Project	<b>IEEE 802.16 Broadband Wireless Access Working Group</b> < <a href="http://ieee802.org/16">http://ieee802.org/16</a> >	
Title	<b>Changes on Downlink and Uplink Resource Allocation in OFDMA-PHY</b>	
Date Submitted	<b>2004-01-02</b>	
Source(s)	Chulsik Yoon, Jaeheung Kim, Kunmin Yeo, Soonyong Lim, Byunghan Ryu ETRI 161 Gajeong-Dong, Yuseong-Gu, Daejeon, Korea	Voice: +82-42-860-6826 Fax: +82-42-860-6732 mailto: <a href="mailto:csyoon@etri.re.kr">csyoon@etri.re.kr</a>
Re:	This is a response to a Call for Comments IEEE 802.16e-03/58 on IEEE 802.16e-03/07r5	
Abstract	This document contains more efficient downlink and uplink resource allocation method in OFDMA-PHY for mobility support applications.	
Purpose	The document is submitted for review by 802.16e Working Group members.	
Notice	This document has been prepared to assist IEEE 802.16. It is offered as a basis for discussion and is not binding on the contributing individual(s) or organization(s). The material in this document is subject to change in form and content after further study. The contributor(s) reserve(s) the right to add, amend or withdraw material contained herein.

# Changes on Downlink Resource Allocation in OFD

*[Replace the Figure 208 to the following Figure 208a and 208b:]*

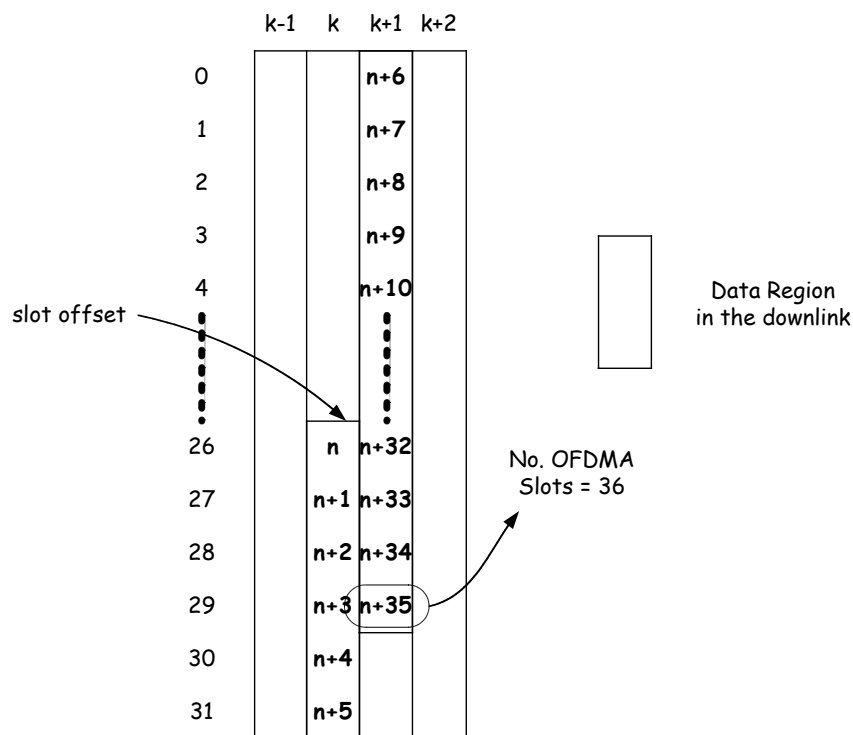
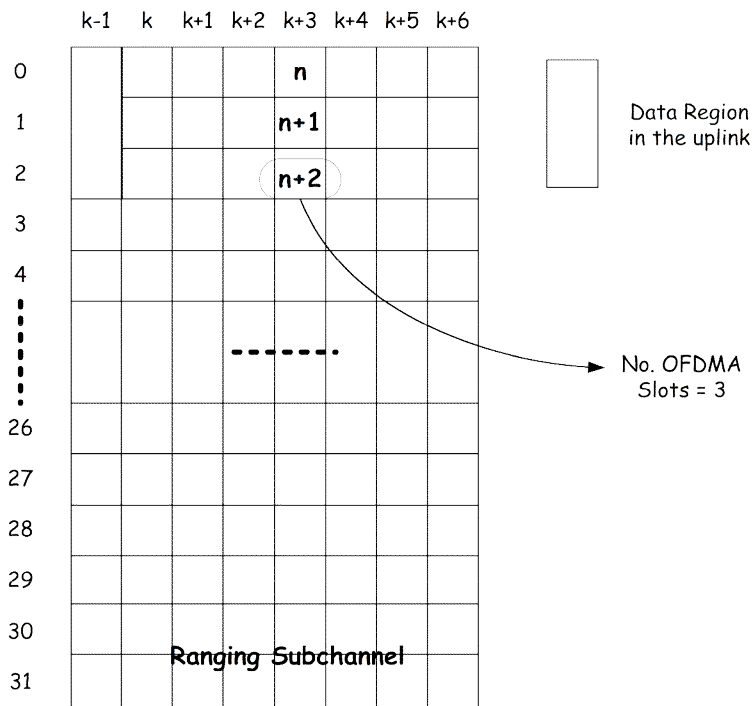
On the downlink allocation, an OFDMA slot is one subchannel by one OFDMA symbol for a regular subchannels, and one mini-subchannel by three OFDMA symbols for mini-subchannels. On the uplink allocation, an OFDMA slot is one subchannel (or minisubchannel) by the number of OFDMA symbols configuring the uplink subframe.

In OFDMA, a Data Region is an allocation of a group of contiguous sequence of slots, such as the block in Figure 208.

Figure 208a Example of the data region which defines the OFDMA allocation in the downlink

Figure 208b Example of the data region which defines the OFDMA allocation in the uplink

*[Replace the Figure 209 and Figure 210 to the following Figure 209a, Figure 209b and Figure 210a, Figure 210b:]*

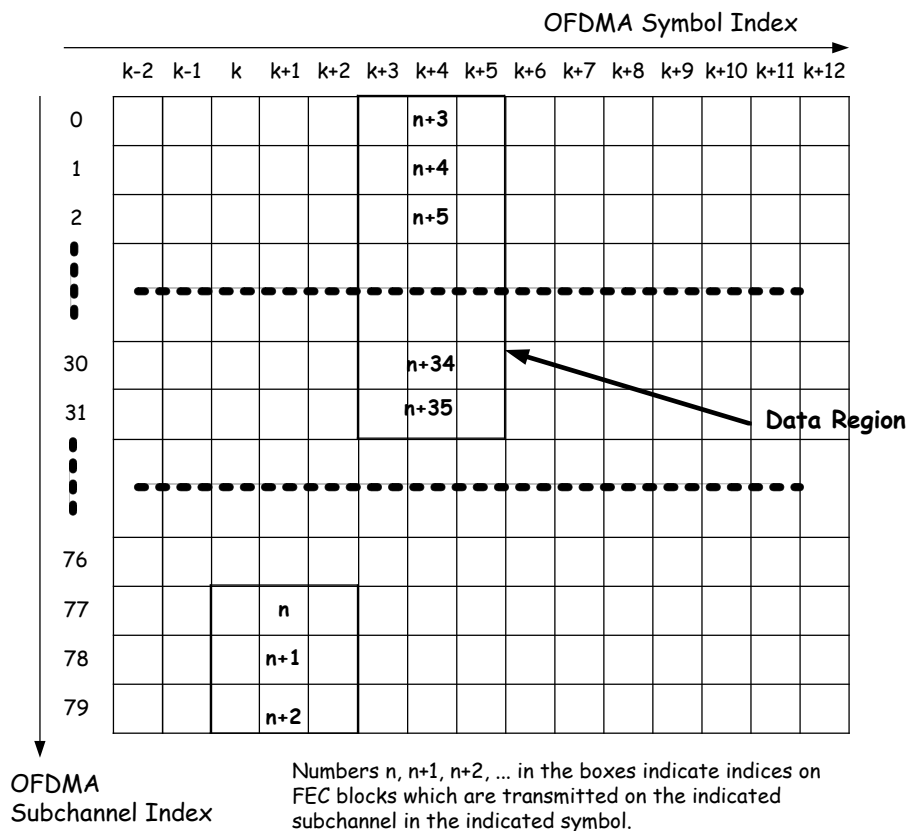
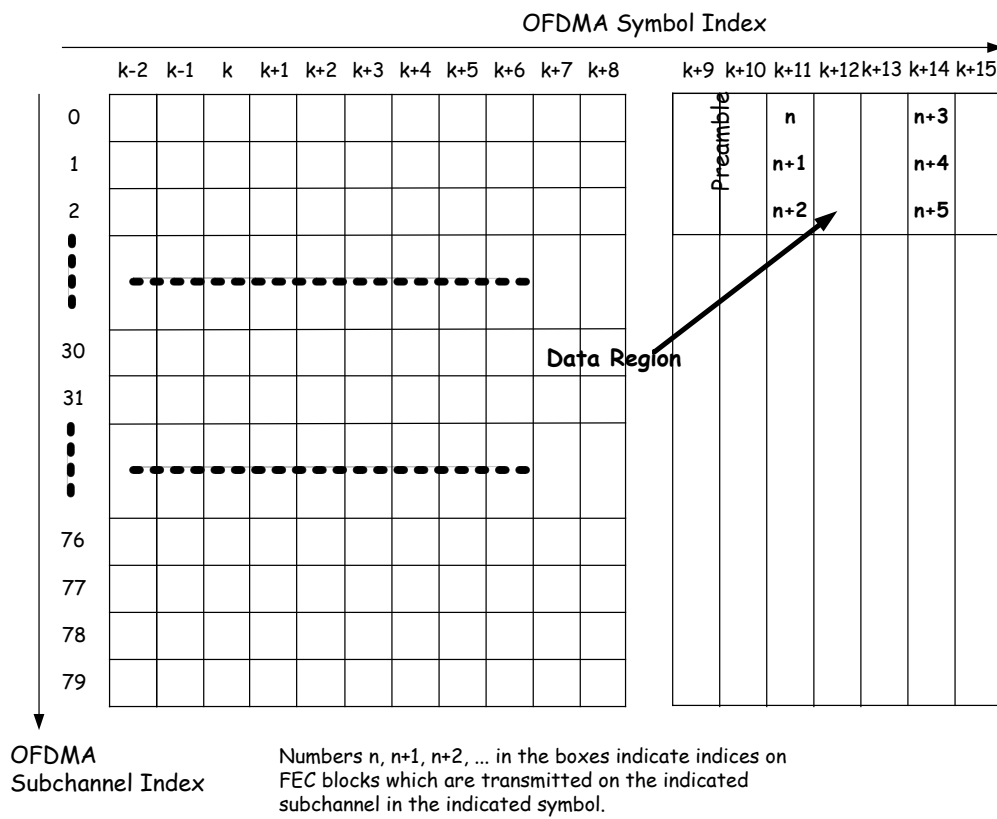
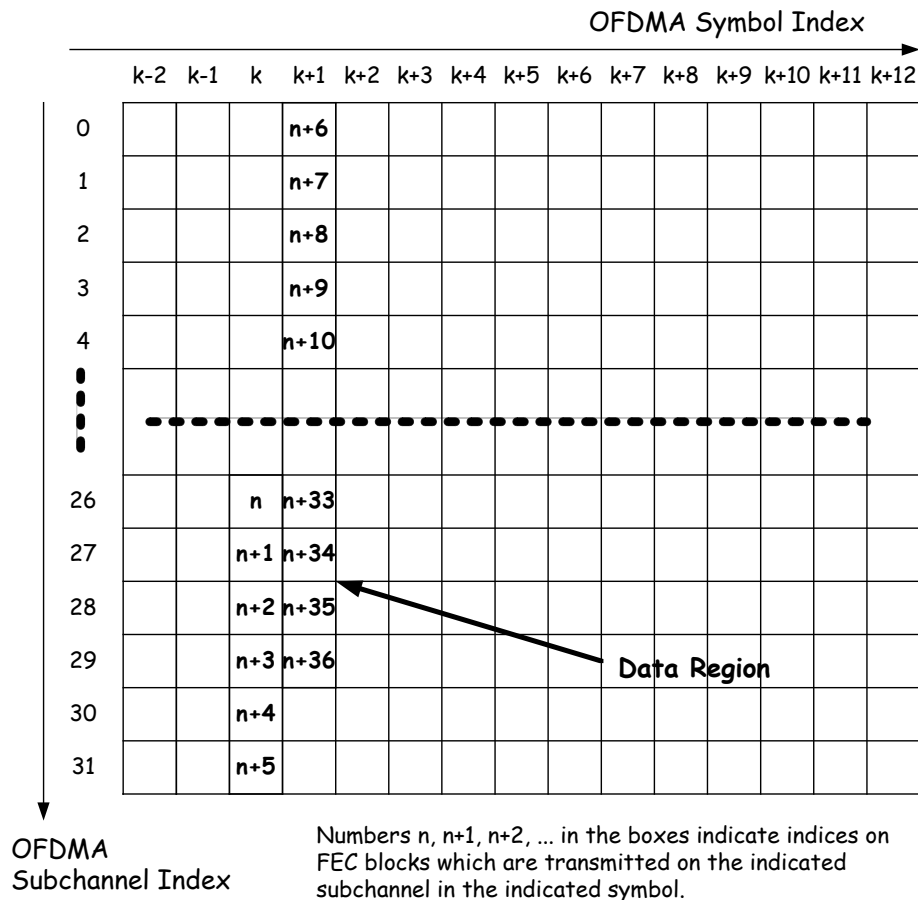
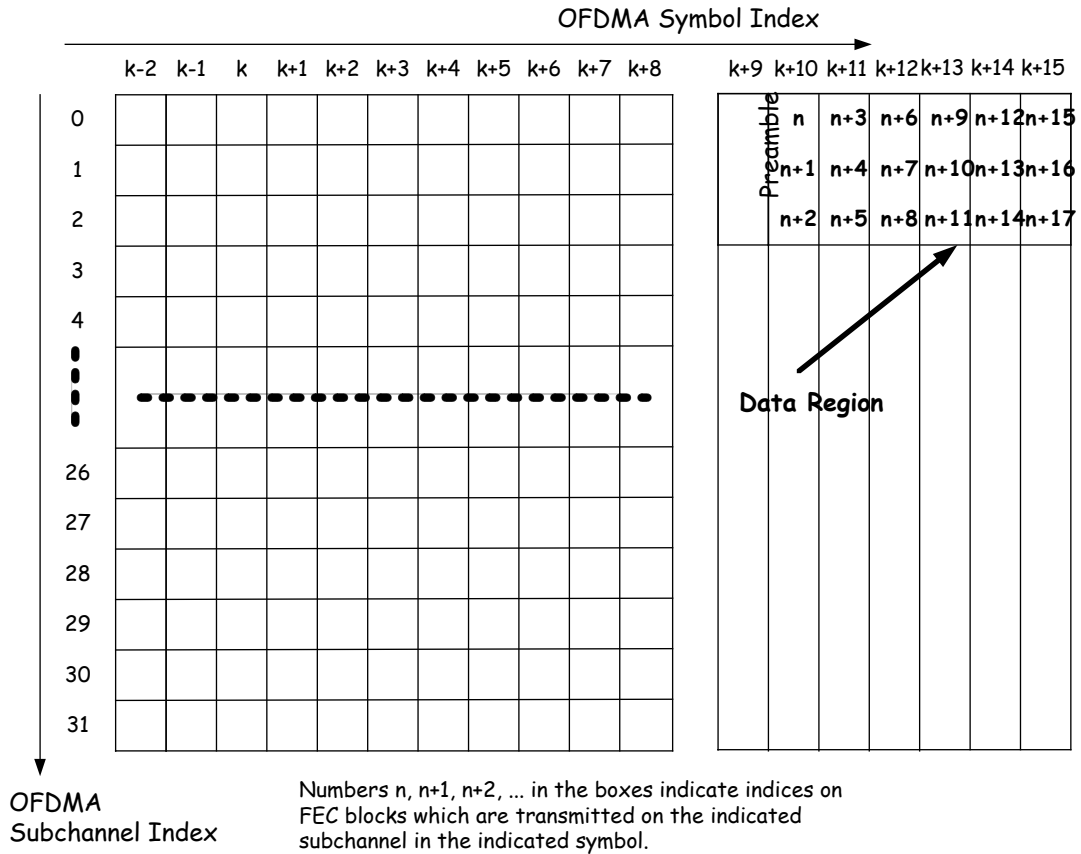
- 1) Segment the data into blocks sized to fit into one FEC block.
- 2) Each FEC block spans one subchannel in the subchannel axis and one OFDMA symbol in the time axis (see figure 210). In addition, when mini-subchannels are employed for the uplink direction, each FEC block spans three OFDMA symbols in the time axis (see Figure 209). Map the FEC blocks such that the lowest numbered FEC block occupies the lowest numbered subchannel in the lowest numbered OFDMA symbol.
- 3) Continue the mapping such that the subchannel index is increased for each FEC block mapped. When the edge of the Data Region is reached, continue the mapping from the lowest numbered subchannel in the next OFDMA symbol.

Figure 209 and Figure 210 illustrate the order in which FEC blocks are mapped to subchannels and OFDMA symbols.

Figure 209a Example of mapping FEC blocks to subchannels and symbols in the downlink when using mini-subchannels

Figure 209b Example of mapping FEC blocks to subchannels and symbols in the uplink when using mini-subchannels

Figure 210a Example of mapping FEC blocks to subchannels and symbols in the downlink.

Figure 210b Example of mapping FEC blocks to subchannels and symbols in the uplink.

Figure 211 Time plan – one TDD time frame

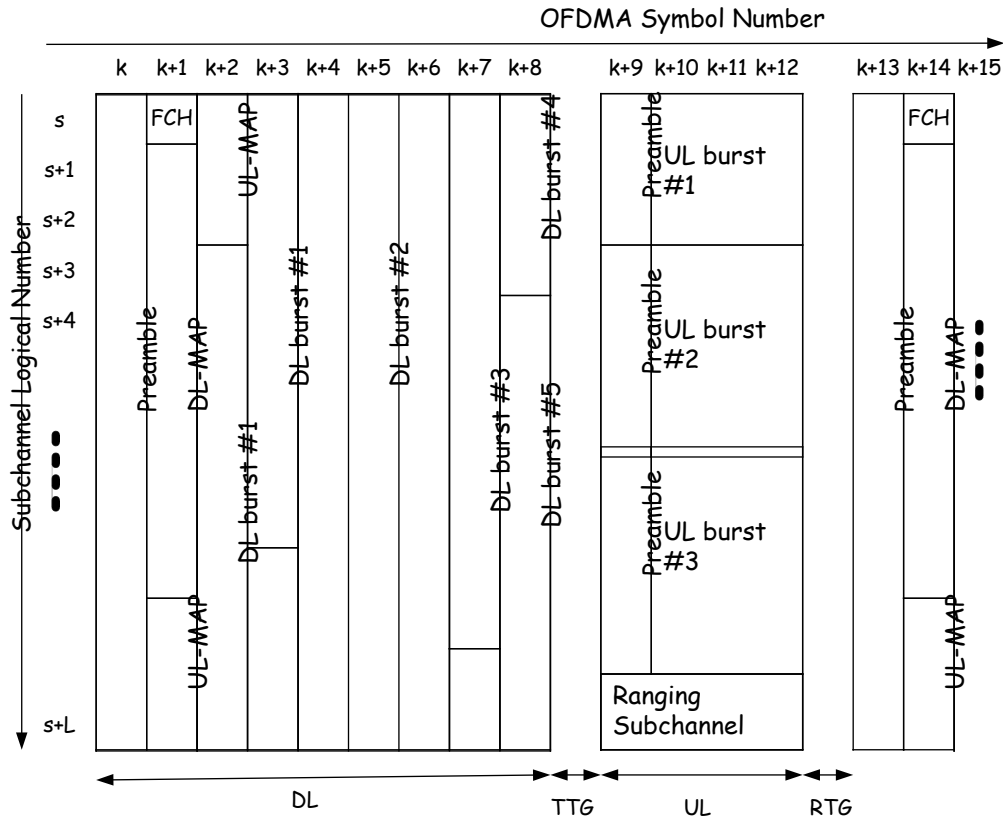
[Replace the Figure 211 to the following:]

The downlink bursts are transmitted in order of decreasing robustness. For example, with the use of a single FEC type with fixed parameters, data begins with QPSK modulation, followed by 16-QAM, followed by 64-QAM.
